BULLETIN NUMBER: SB-0013

K-XESC – Side Shift Cylinder Control

NOTE: This bulletin is applicable to K-Series XE with Section Control prior to Manufacture build date 01/01/2023.

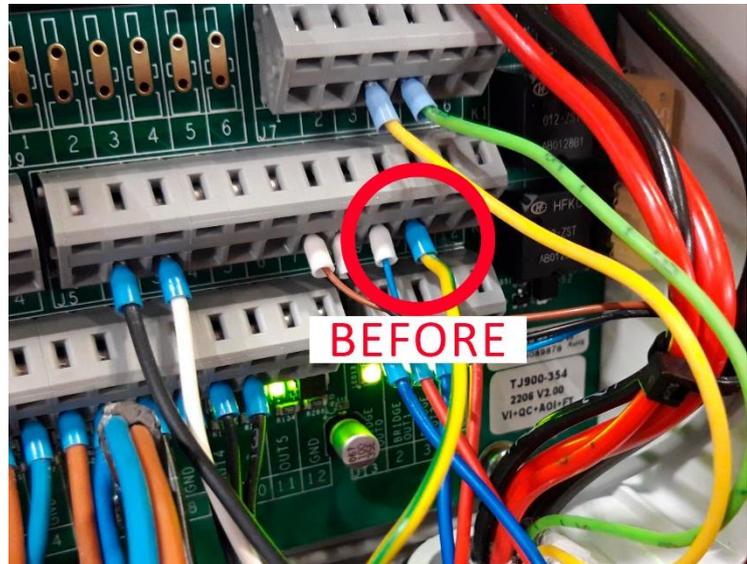
1. Update the main program to version 3.00

- Download the software off the "[Bredal Australia](#) > Dealer Portal Link"
- When you receive the program, save the complete file **tjrun** on a USB memory stick.
- Ensure you FAT32 format the USB before you save the software.
- Turn on the VT terminal and wait until the Bredal operating system has booted up.
- Insert the USB memory stick in the spreaders junction box on the ISO-BUS controller:

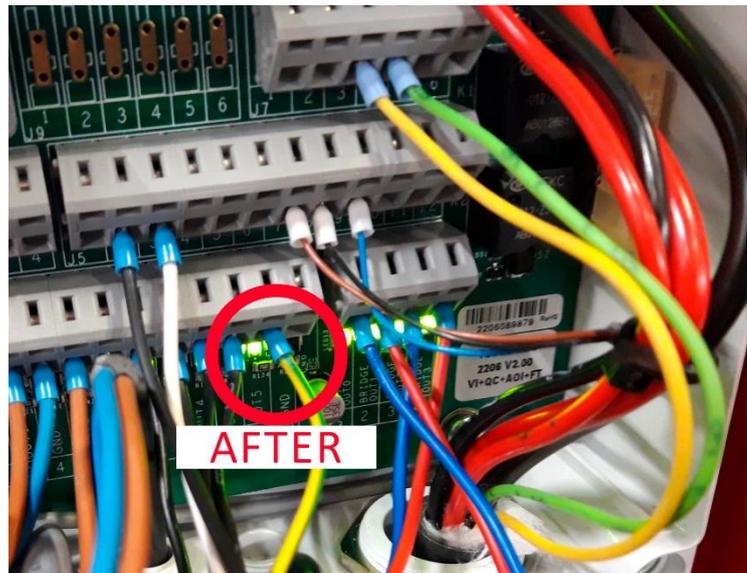
2. Move the yellow/green 12V supply wire from J5 - pin 10 to J12-pin 11. (see photos and attached diagram)

Before update: J5 – pin 10

After update: J12 – pin 11
